TO: Board of Supervisors Agenda of: April 3, 2012

RE: Rezone Z10-0009/Planned Development PD10-0005/Tentative Parcel Map P10-0012/Creekside Plaza

The revised Master Plans result in changes to the following: **Section A** is a clarification/correction to the Initial Study; **Section B** includes Staff Report Attachment 1 exhibit changes; and **Section C** includes Staff Report, Attachment 1 recommended condition changes:

Section B. Staff Report, Attachment 1, Exhibit Changes: Staff recommends the project exhibits be revised as follows:

FIGURE: 1

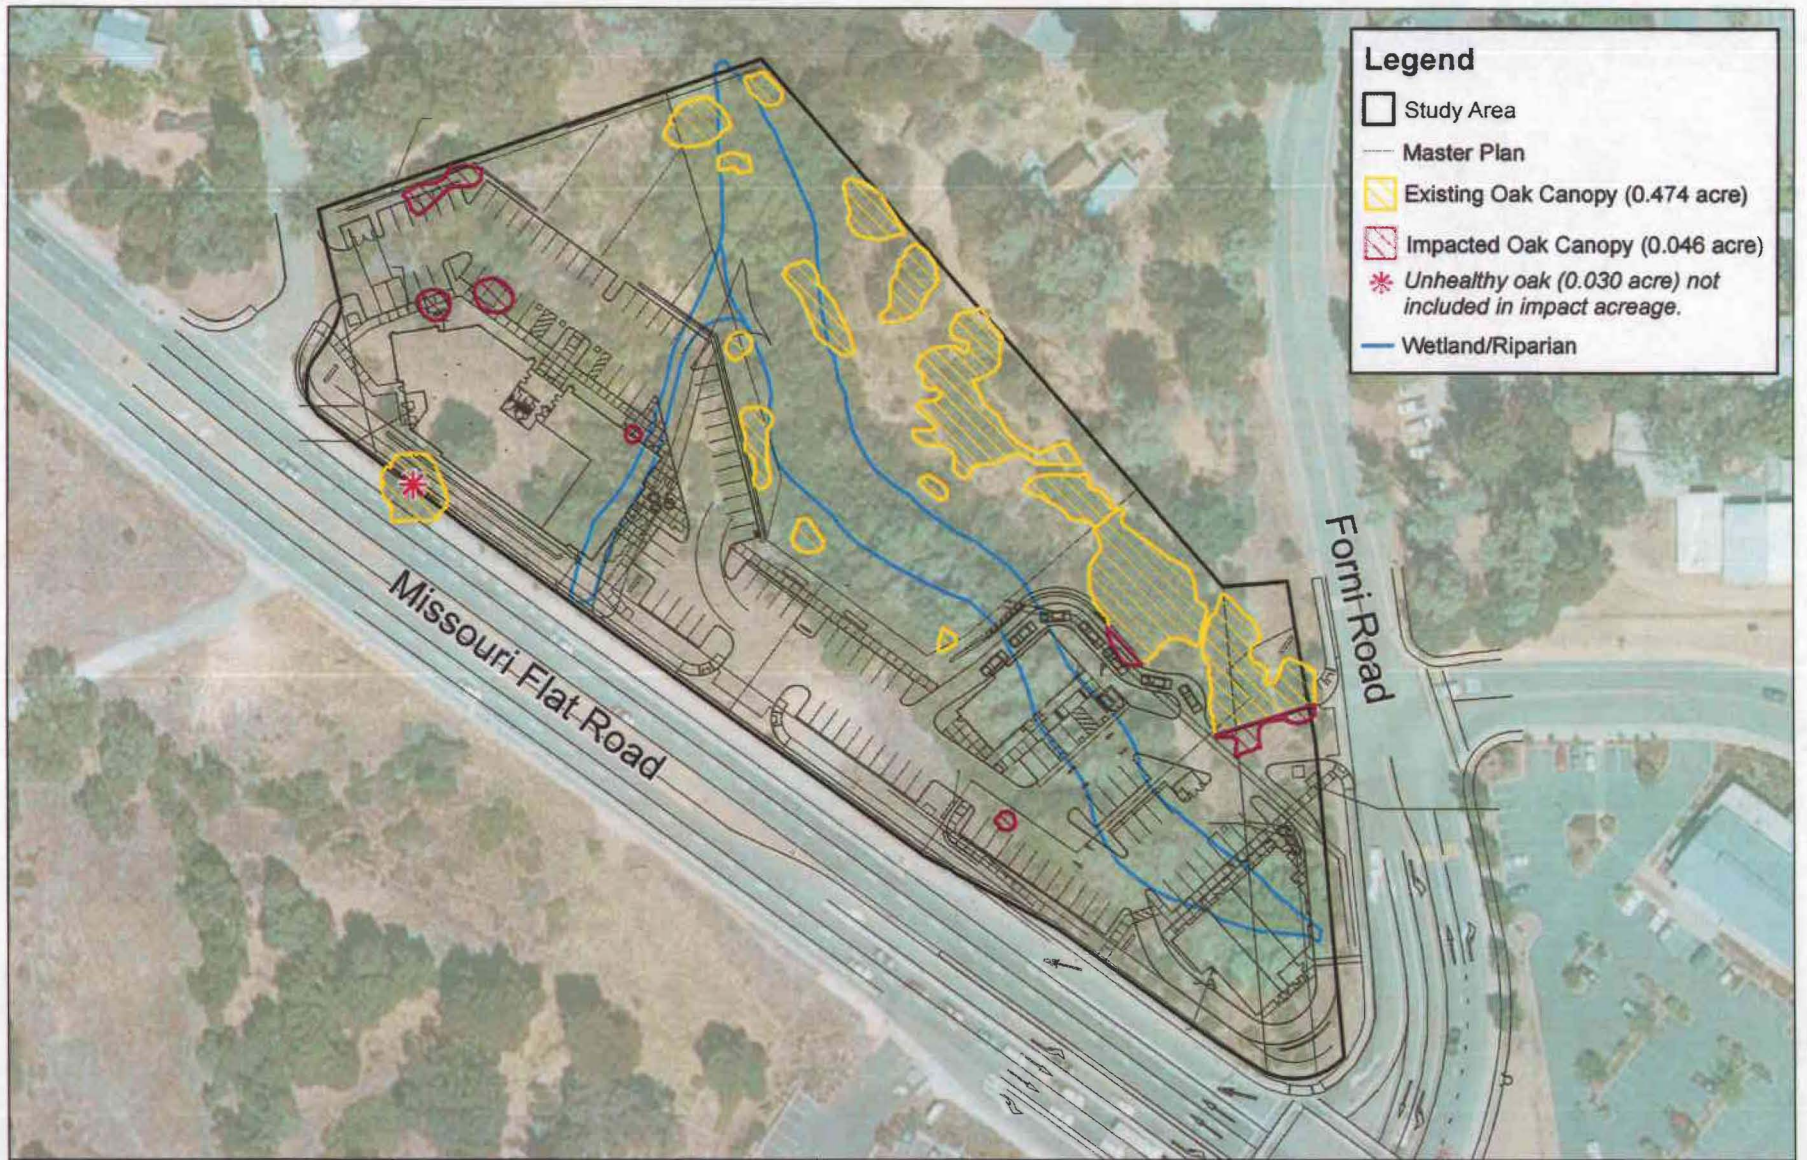
The March 2012 site plan was subsequently overlaid to determine the area of impact to the oak canopy that would occur with implementation of the proposed project. Analysis of the project site plan in relation to the existing oak canopy cover determined the project would remove 0.046 acre of the existing on-site oak canopy. The study area has an existing cover of approximately 11%, which would require 90% retention under Section 17.73.070 of the County Code. Based on this requirement, 0.427 acre (90%) of the existing oak canopy must be retained. The project proposes to retain 0.428 acre of oak canopy, which fulfills the 90% oak canopy retention requirement. The project also proposes to replant the impacted 10% oak canopy at a 1:1 mitigation ratio on-site.

The landscape plan developed for this site proposes planting a mixture of valley oak (*Quercus lobata*) and interior live oak (*Quercus wislizeni*) for a total of 31 oaks. These species either grow on the property or in areas surrounding the property. As the project will impact 0.046 acre of oak canopy, replanting this number of trees will far exceed the requirement for the replacement of oak tree canopy at a 1:1 ratio.

Arborist Report: (2-17-2012)

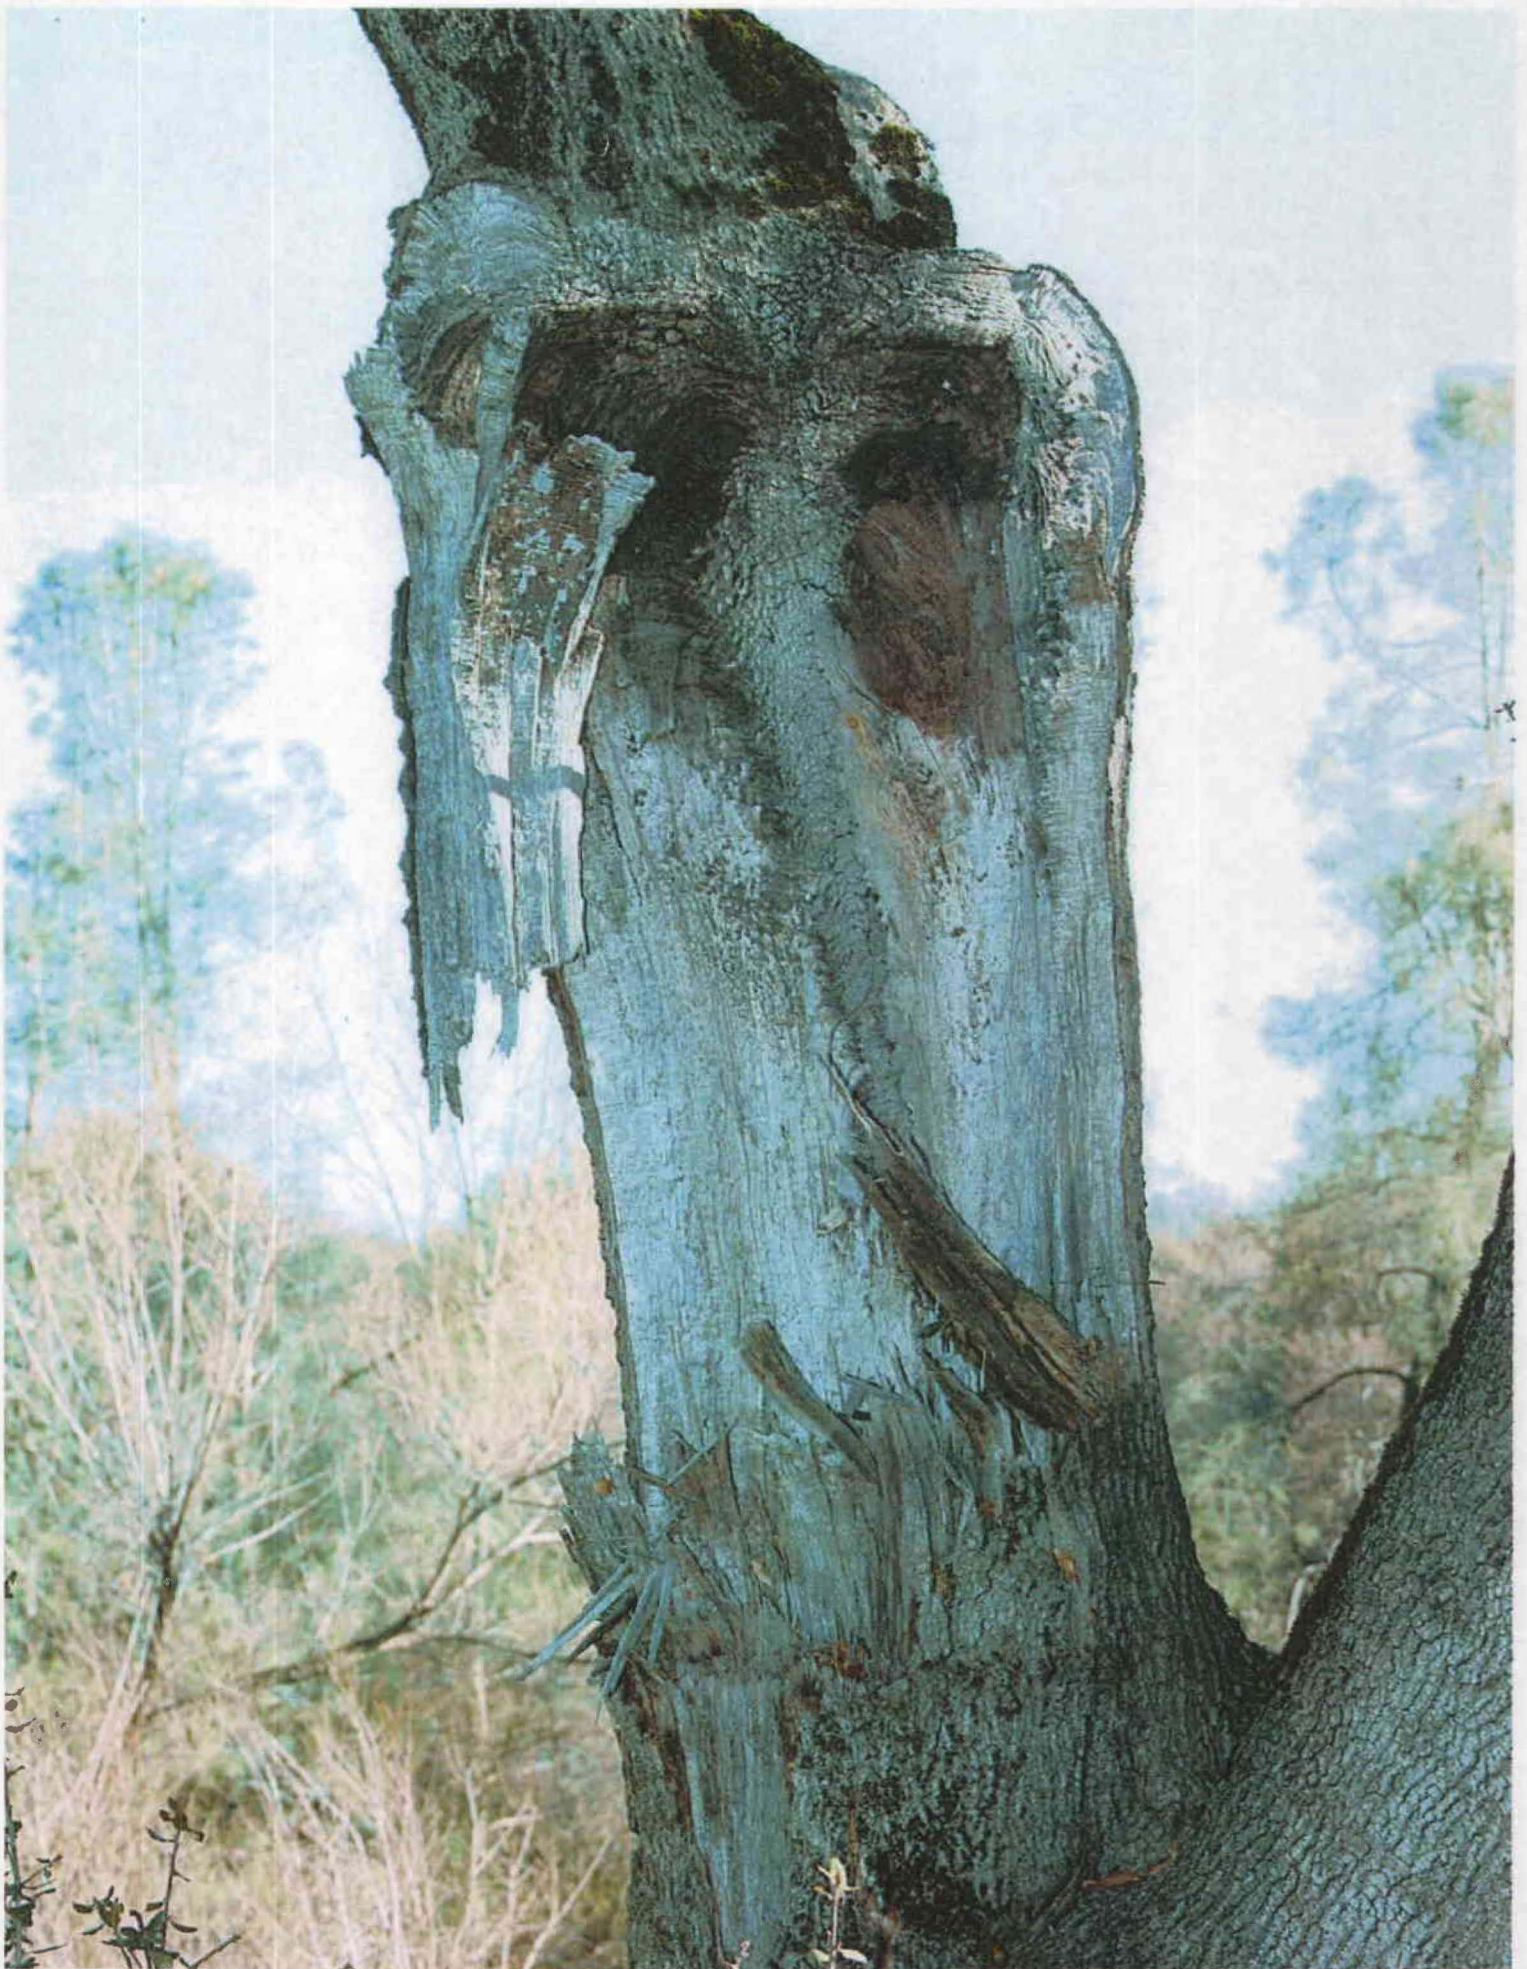
This evergreen is hanging over an area which is planned to be constructed on for an extension of roadway. After observing the tree and its condition, I immediately noticed that it has a potentially dangerous lean with excess weight protruding towards the road. If the tree was to remain present during or after the construction, the root system would be severely impacted and would create a hazardous situation for workers, drivers and pedestrians.

If this tree were to remain standing after the extension of road it would be very dangerous. I highly recommend its removal before construction. There is approximately 70% of the tree hanging over the road at the present time.

There is an excessive amount of rot throughout the tree and at the base of the trunk there are open cavities. Also noted are scars from areas where large limbs have ripped off and fallen. I highly recommend that this tree be removed.

EXHIBIT F-1

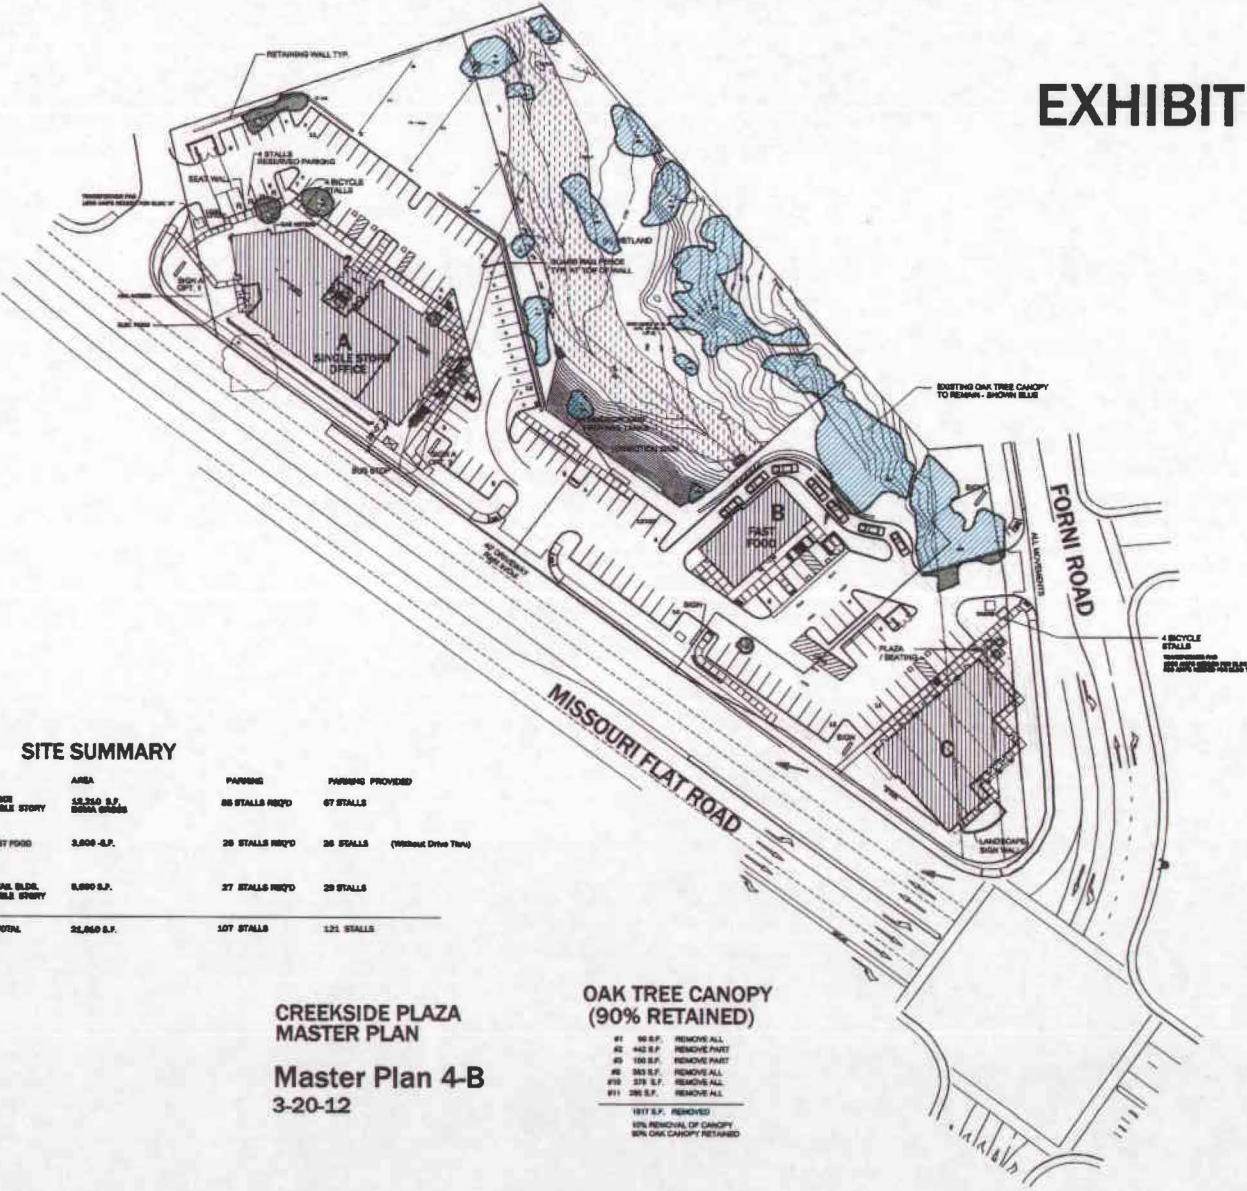
- 1) Fast Food building “B” and the drive thru has been shifted westward to allow for the preservation of existing oak canopy. The retail portion of building to the east has been deleted.

- 4) Parking has been reduced to preserve oak tree canopy. The minimum required stalls for each building are provided. The exterior seating at plaza(s) will be limited to the extra stalls provided within the development.

- 7) Building “A” office has been reduced from 2 stories to 1 story. The architecture remains unchanged other than the second floor removal. The parking area has been reduced accordingly.

- 10) 3 large parking stalls (12’x22’) have been provided at the request of Planning Commission. The stalls are located central to project near exit of fast food drive thru.

Parking shall conform to the Site Plan (~~Sheet S1 Creekside Plaza Master Plan 4-B, Sheet A-1 dated March 20, 2012, Exhibit F-1~~), in combination with ~~Sheet S2 Plaza Master Plan 4-A, Sheet A-1 dated March 20, 2012 (Exhibit F-2)~~, if that option is chosen for Building C, and as follows:

15. **Oak Canopy:** The project shall comply with General Plan Policy 7.4.4.4 Option A by: 1.) removing no more than .046 acres as shown in the Creekside Plaza Master Plan4-B, Sheet A-1 dated March 20, 2012 (Exhibit F-1); and 2) implementing the oak canopy mitigation plan described in the Revised Oak Canopy Analysis for Creekside Plaza dated March 20, 2012. ~~shall remove 0.60 acres of oak canopy (13.3 percent of total existing). The required 90 percent retention of oak canopy as established by the General Plan shall be achieved through payment of a \$3,196.00 (0.06 acre at a 1:1 ratio; 0.31 acre at a 2:1 ratio) in lieu fee. Said fee shall be paid prior to issuance of a building and/or grading permit and/or filing of the Parcel Map.~~

EXHIBIT F-1-A

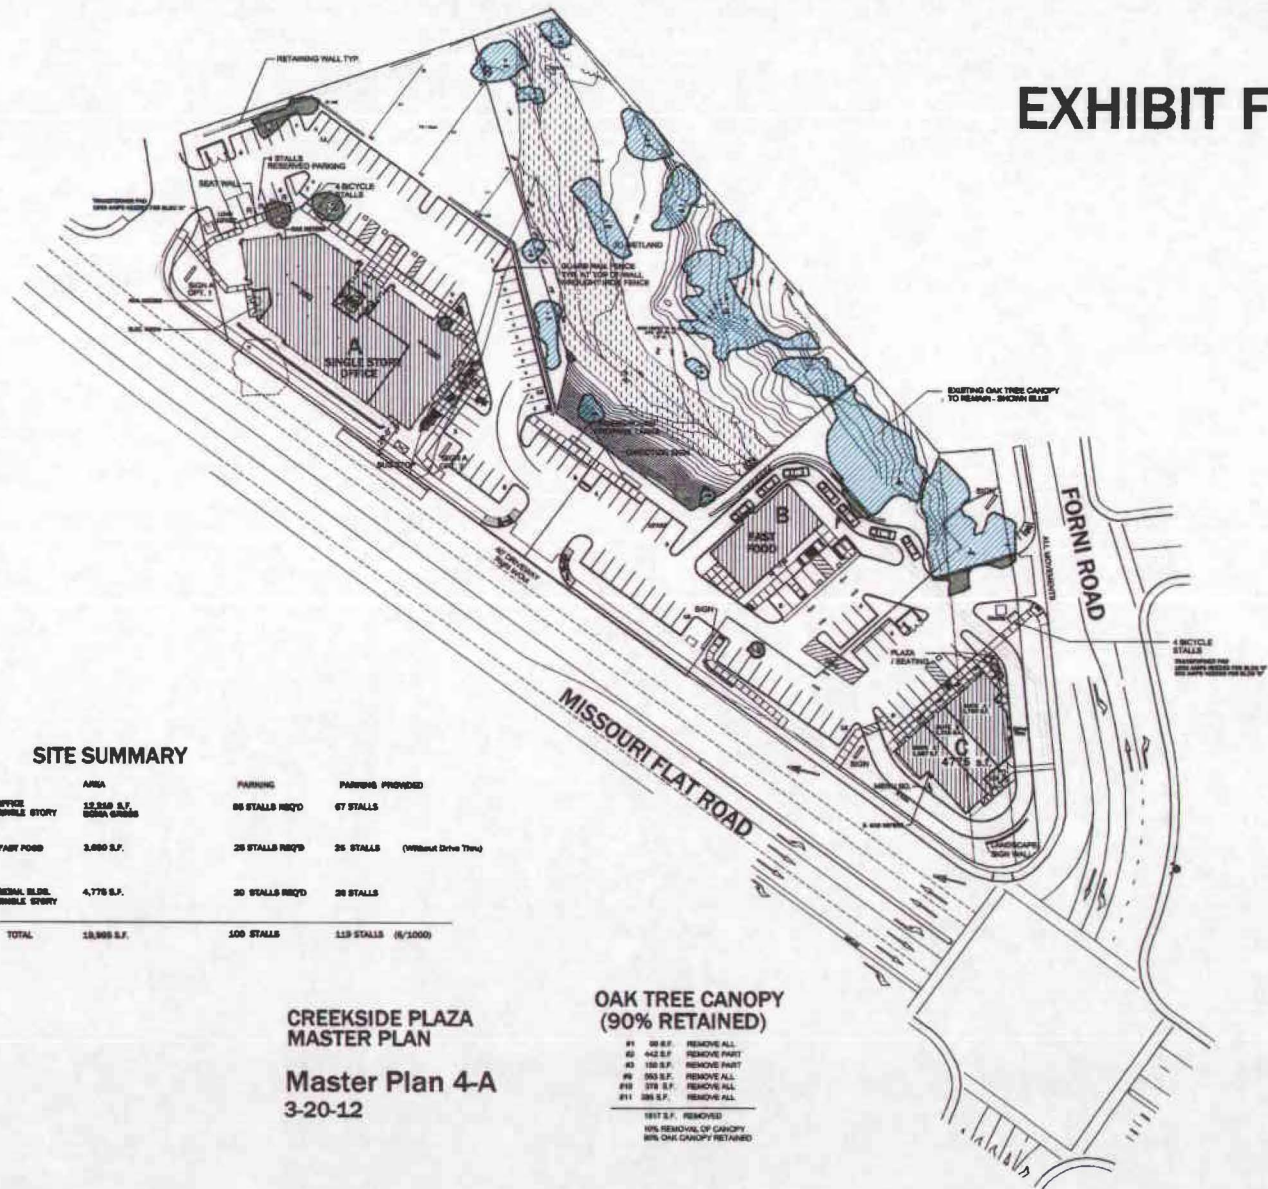
- 2) No revision to Building “C”. The two options for building remain unchanged from previous approval.
- 3) One monument sign near Forni Road entry has been shifted to preserve oak tree canopy.
